21-COA-0074 1451 S. 2nd St.

Old Louisville Architectural Review Committee Public Hearing

> Bradley Fister, Historic Preservation Specialist May 12, 2021

Request <u>Certificate of Appropriateness</u>:

Back Yard + Alley

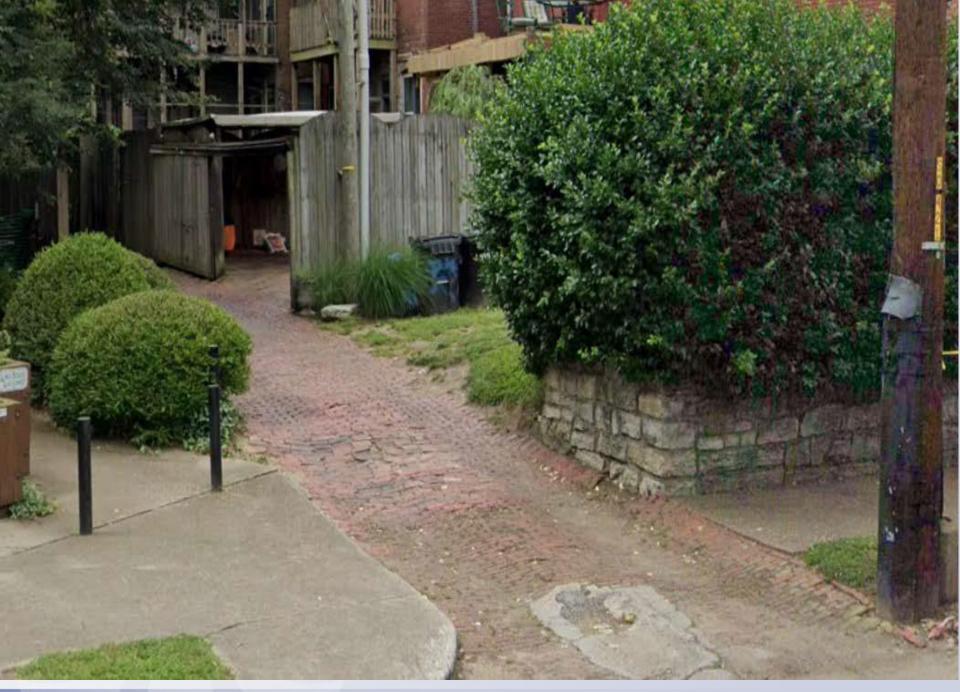
- Repoint Existing Retaining Wall
- Construction of New Retaining Wall (next to existing) in Order to Create a Level Rear Yard.
- Construct Privacy Fence and Barn Style Gate to Create Secure Private Parking
- Height of the Fence is Based on Existing Fences Along the Alley (goal was to create a continuous visual sightline)

1453 S. 2nd St. Overall Height 8'-4" +/-

The privacy fence, and gate located at the rear of the property would generally meet the design guidelines for Site, other than the height is above the 7' maximum height as stated in the Design Guidelines. Though staff cannot recommend the privacy fence based on the Design Guidelines, staff recognizes the height is in keeping with the condition of the neighboring privacy fences in the alley. The height of the fence was chosen to follow this existing site line to create a more cohesive continuous feel.

However, the LDC measures from grade level which would be in this case at the base of the retaining wall. This would make the height more than 8' max height per the LDC. If approved the applicant may require a variance for the height.

1. The applicant shall lower the height of the privacy fence and gate to a maximum of 7' above grade.
